**Re: Miami Cove Subdivision Waterlines (PR#72-2023)  
Garibaldi Water System (PWS ID# [00311](#))  
Conditional Approval**

Miami Cove Subdivision Waterlines served by the Garibaldi Water System (41-00311)  
 Conditional Approval – PR #72-2023

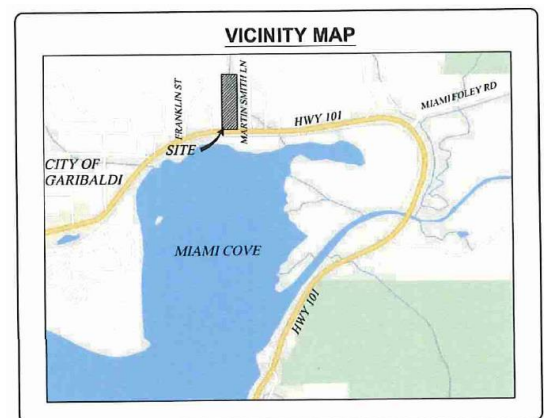
1. New facilities are disinfected and tested per the latest AWWA standards and [OAR 333-061-0050\(10\)](#).
2. Design ensures pressures be less than 20 psi at the meter to the apartment complex and at each single-family dwelling per [OAR 333-061-0050\(8\)\(e\)](#).

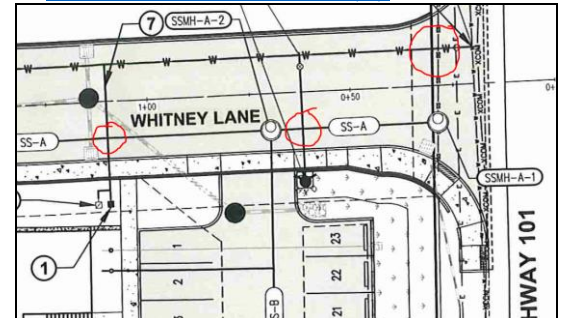
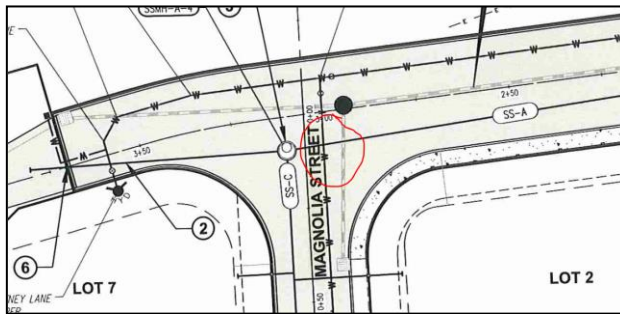
3. The bottom of the waterline is at least 1.5-ft above the top of the sewer line where they cross (4 locations circled below) in conformance with [OAR 333-061-0050\(9\)](#).
